Re: **Case No. 08-170-EL-BTX**  
**OSU-Roberts 138kV Transmission Line Project**  
**Staff Questions/Clarifications Set#3**

**Roberts-OSU 138kV Transmission Project  
OPSB Case No. 08-0170-EL-BTX**

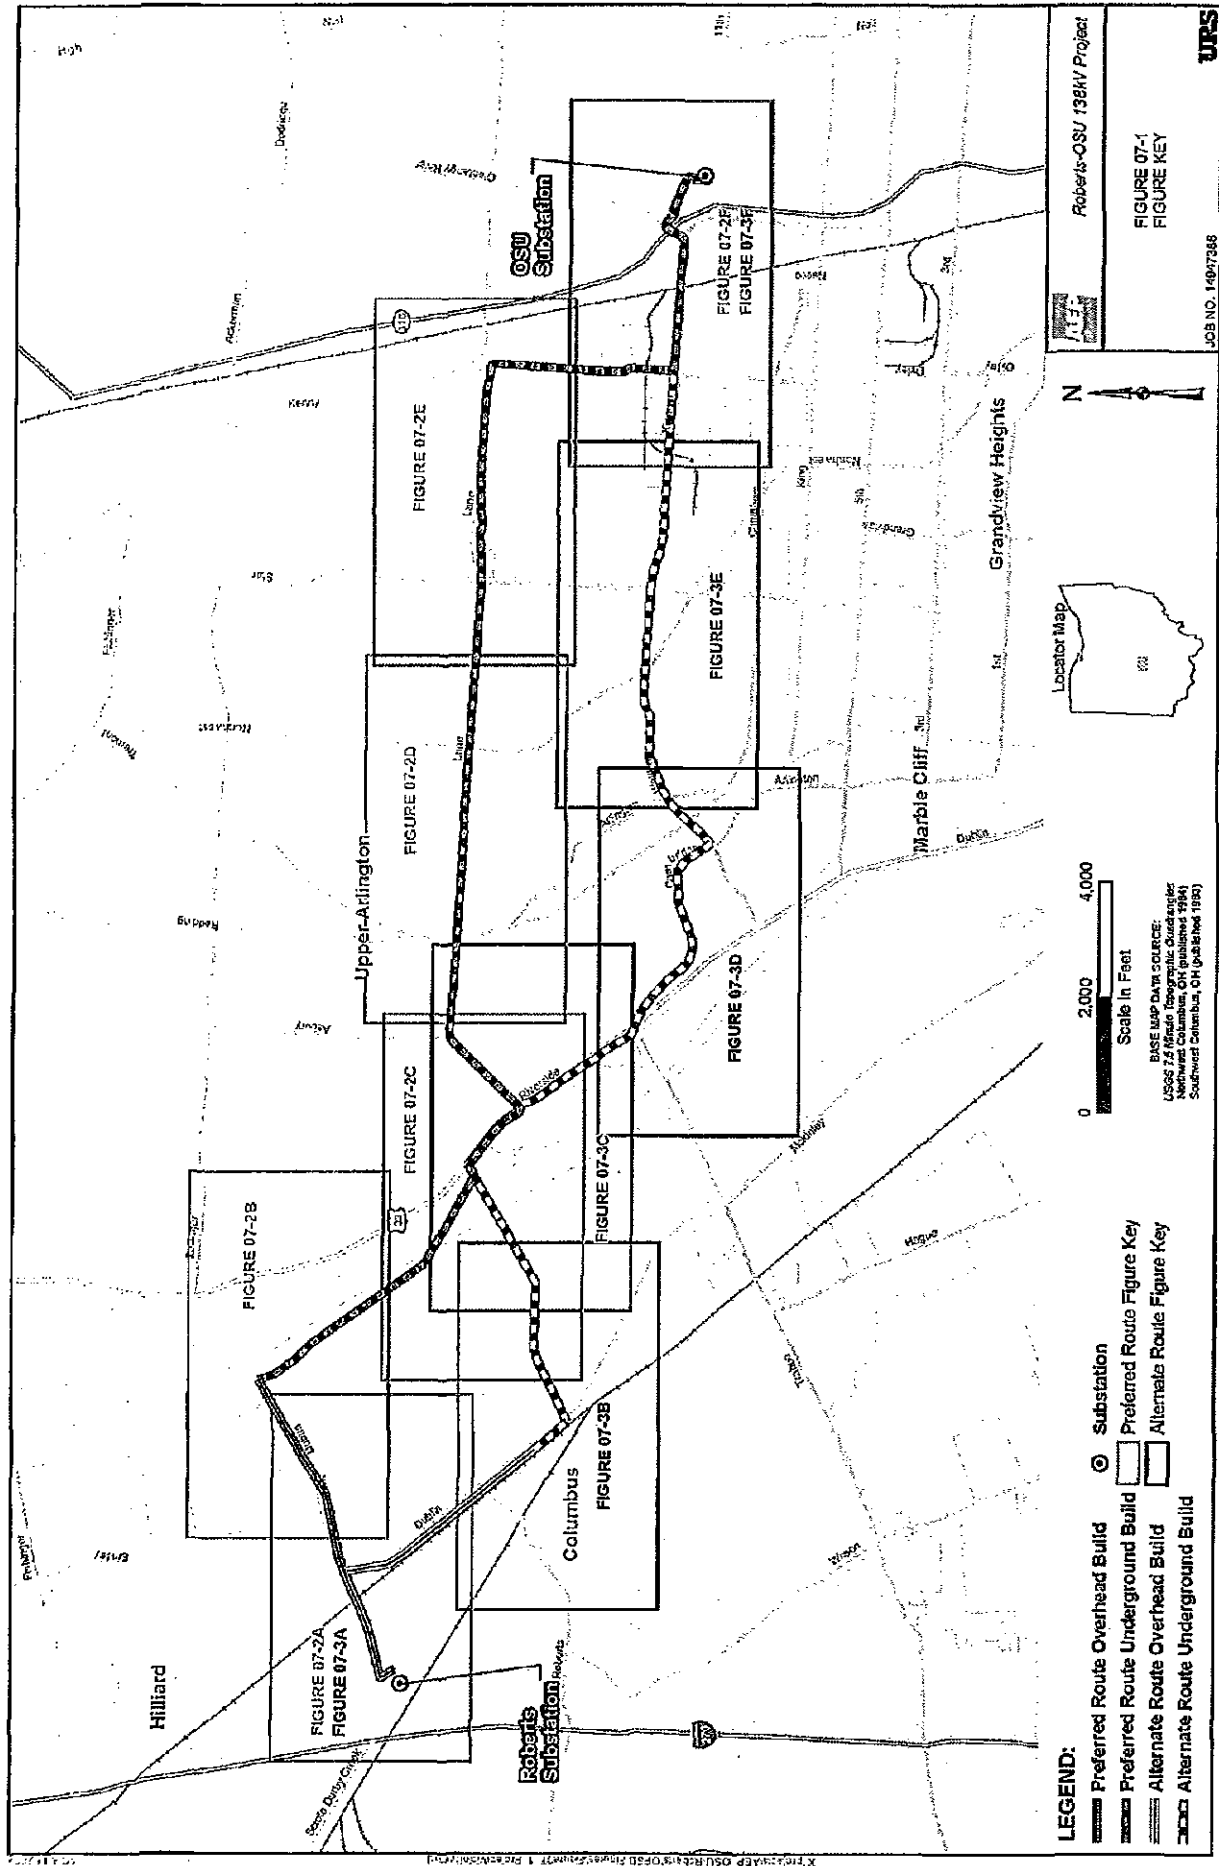
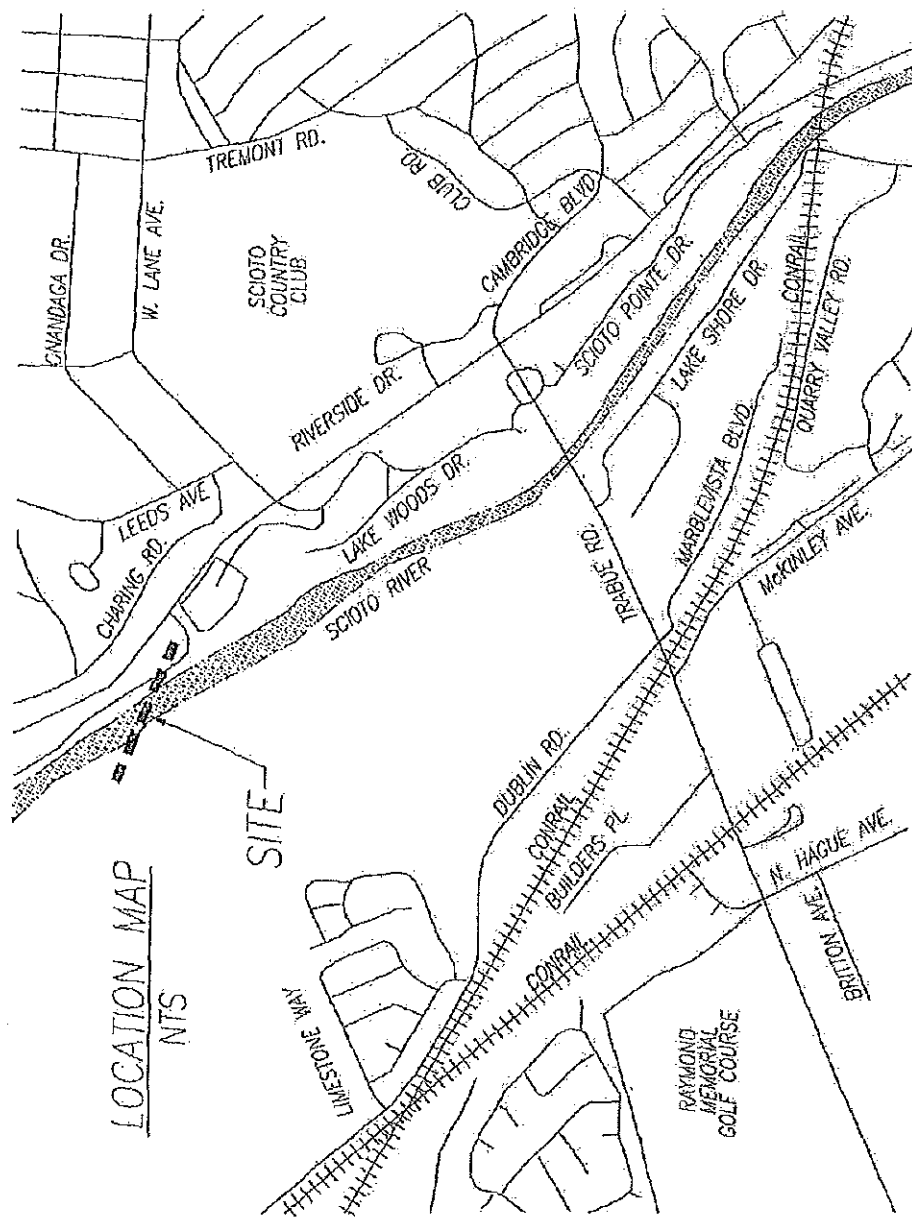
8. *Are suitable roosts for Indiana bat habitat trees likely to be cleared? If yes, please identify the area(s) and describe what is proposed to be cleared, including photos if helpful.*

Based on the studies conducted to date on the project, there is a low potential for Indiana bat to occur along the project route. Density of wood lot is low, clearing is limited and the quality of the wooded area is poor. The only area where woodlots occur is along the Project is from the Roberts substation east to the Scioto River, the remainder of the Project follows road right of way in a highly urban setting.

The area between the Roberts substation and Scioto River is the Marble Cliff Limestone Quarry. The Preferred Route parallels woodlots that occupy the fringe of the quarry property and are long and narrow, fragmented, and contain young less desirable Indiana bat tree species such as black locust (*Robinia pseudoacacia*), red maple (*Acer rubrum*), eastern cottonwood (*Populus deltoides*), and various other tree species that preferentially inhabit disturbed areas. One approximately six acre woodlot on the northeast corner of the quarry property is comprised of sugar maple (*Acer saccharum*), red maple, and eastern cottonwood that range in diameter from 5 to 12 inches at

breast height. The understory is comprised of Japanese honeysuckle (*Lonicera japonica*) and young saplings. Other woodlots south of the quarry that are passed through by the Alternate Route are fragmented by old roads and other utilities. Trees within these woodlots are composed of eastern cottonwood, sugar maple, black locust ranging in diameter from 4 to 12 inches at breast height. Tree species commonly used by Indiana bats include various ash (*Fraxinus*), elm (*Ulmus*), hickory (*Carya*), maple (*Acer*), poplar (*Populus*), and oak (*Quercus*) (USFWS, 2007). Although some trees found within the quarry woodlots are of species sometimes used by Indiana bats, the dbh of the trees within the woodlots are smaller than typical roost trees, which are 16 inch dbh or greater (USFWS, 2007).

The first mile of the Preferred Route will be a pole for pole replacement of the existing Kenny – Roberts 138 kV line. Replacement of original poles with new poles at the same locations, little to no clearing will be required since this stretch is existing right-of-way (ROW). The last tenth of a mile will pass through the small six acre woodlot which will require an 50 foot wide corridor to be cleared. Once the Preferred Route turns southeast, the underground portion of the line will begin and will require a 100 foot wide corridor to be cleared through the small woodlot. After leaving that small woodlot, the underground portion generally follows a quarry road that contains some small, poor quality trees (<6" dbh). In this area, a 60 foot wide corridor will be cleared. The Preferred Route will then be horizontally directionally drilled (HDD) under the Scioto River, avoiding impacts to the riparian corridor. It is anticipated that no trees will be removed for the HDD pad on the west side of the river, and no trees will need to be removed for the HDD pad east of the river. Once across the Scioto River, both routes remain within existing roads or along the edge of the road ROW requiring little to no trees to be cleared from residential properties, as discussed in the OPSB application. A maximum of approximately 6.6 acres will need to be cleared for this project.

A literature search for previous nearby mist net surveys resulted in one survey that occurred in early August 2004 for the expansion of Britton Parkway in Hilliard, Ohio, approximately four miles north of the Roberts – OSU 138 kV Transmission Line Project. The mist net surveys resulted in only four captures of three different species; however no Indiana bats were captured. Habitat surveyed for the Britton Parkway contained more mature trees and seemed to provide higher quality habitat because of the surrounding land use and its close proximity to riparian and bottomland corridors. Since the completed mist net survey was so close in proximity to the OSU – Roberts Project, it is unlikely that the poorer quality habitat found along the fringes of the quarry will support Indiana bats. A review of the 2007 Indiana bat draft recovery plan indicated that there are no summer or winter records of Indiana bats in Franklin County, Ohio. Also, Franklin County, Ohio does not have any hibernacula records.

After reviewing field data from the wetland delineations along both routes and reviewing the project via aerial photography, it appears unlikely that construction of the Roberts - OSU 138 kV Transmission Line Project will have a negative impact on Indiana bats. This determination was reached based on the lack of forested areas in the area, the tree species present are typically less desirable for roosting habitat, forested areas are highly fragmented, and finally because there will be minimal tree removal and habitat disruption resulting from this project. Furthermore, given that there are no Indiana bat records in Franklin County, Ohio and nearby surveys have not recorded captures, it appears unlikely Indiana bats present in the project vicinity.

ATTACHMENT #2

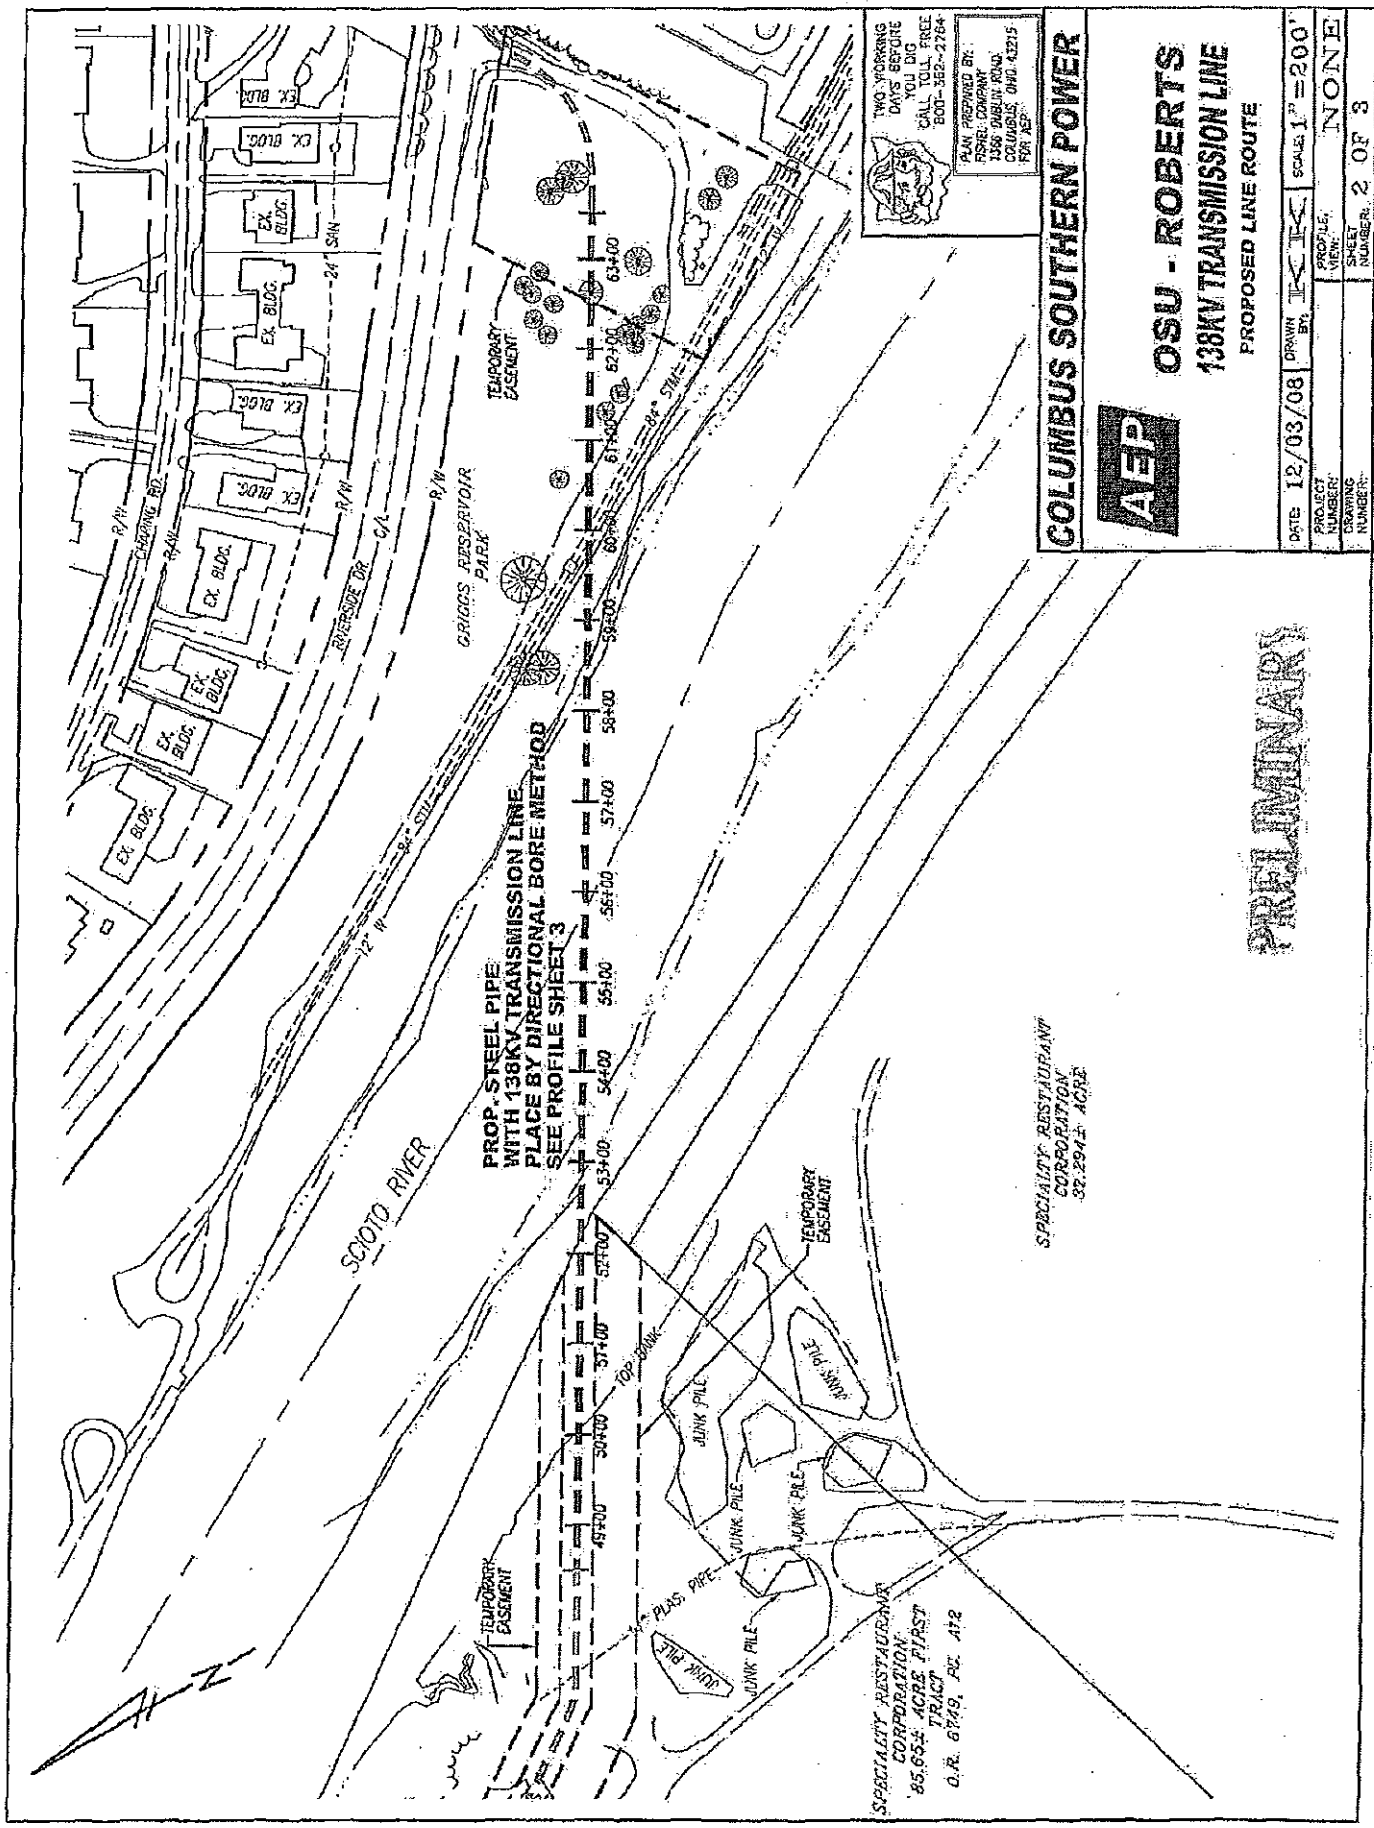
*Please provide a map outlining both crossings, and provide a tentative list of equipment that would be used (including pieces of equipment, outline of impacted area, hours of operation, decibel levels of equipment, and noise mitigation measures or techniques, if any).*

**Preliminary maps outlining both crossings for the preferred route are attached (Attachment #2 and Attachment #3).**

**A typical large horizontal drilling spread can be moved onto a site in approximately seven tractor-trailer loads. The principal components of the spread include rig ramp, drill pipe and control trailer. Other equipment used on the rigging side of the bore include mud pump, fluid system/tank, power unit, crane or backhoe, and bentonite storage. A workspace of approximately 110' wide by 250' long is typically adequate for drilling operations, however, orientation of equipment can be adapted to minimize impacted area.**

**Pull section fabrication is accomplished for a boring operation with the same construction methods used to lay pipeline. Equipment on the pipe stringing side of the river will include typical pipe handling equipment, prefabricated pull sections supported on roller stands, fluid system/tank, and mud pump. Workspace required for pull section fabrication is approximately 60' wide X 200' long aligned with pipe exit point.**

PROFILE SHEET 2 FOR PLAN VIEW

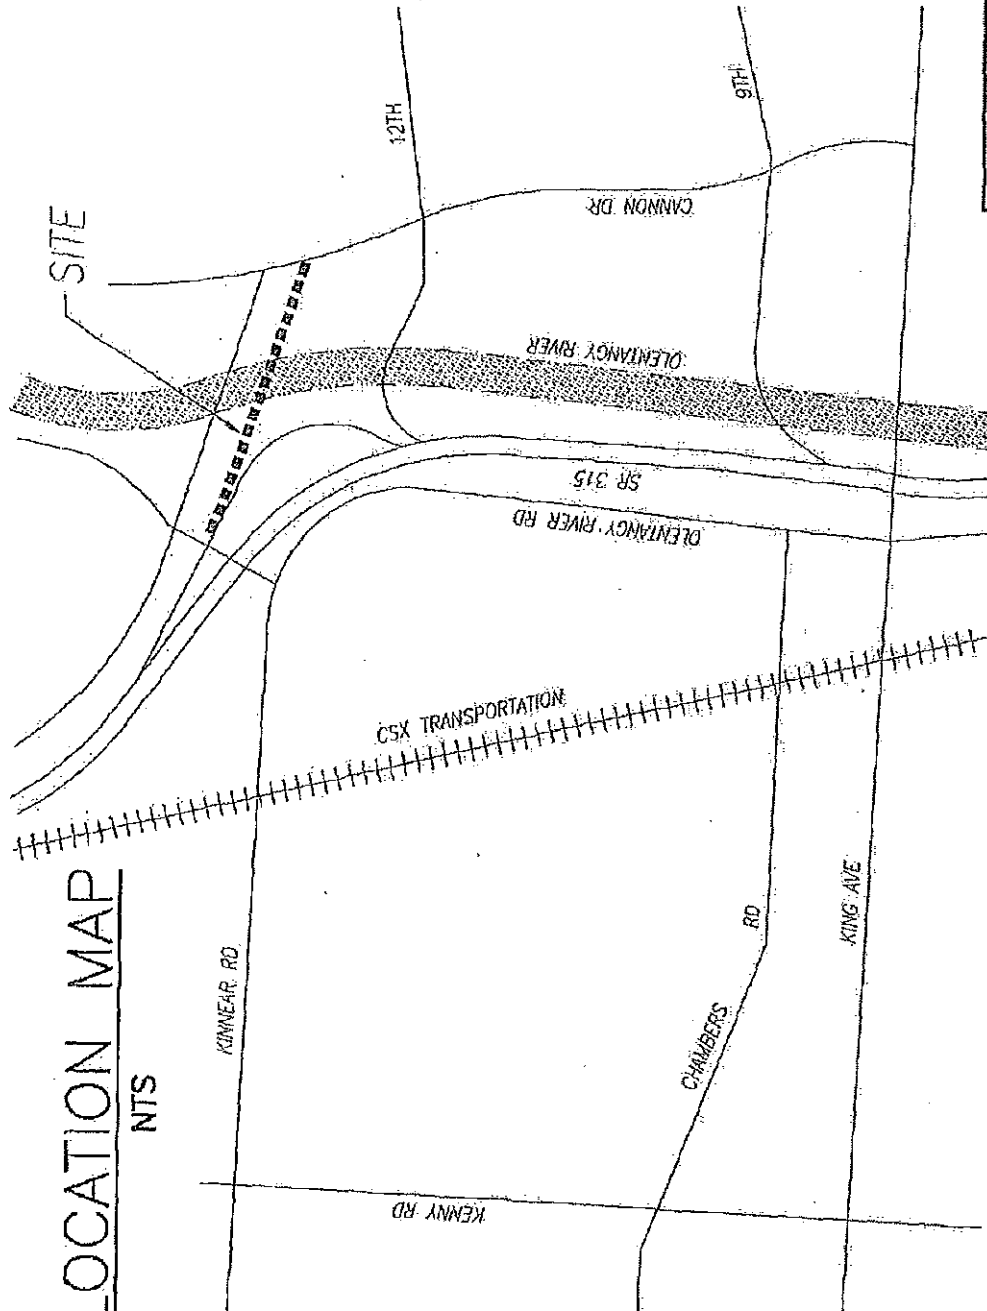
4. *Page 07-6 refers to "boring" being used to cross the Scioto and Olentangy rivers. Please confirm that the bore under the Scioto River will be set up (rigging equipment) on the east side, with pipe strung on the west side of the river (quarry property).*

**The horizontal directional bore under the Scioto River is currently designed with rigging equipment on the east side and pipe on the west side of the river.**
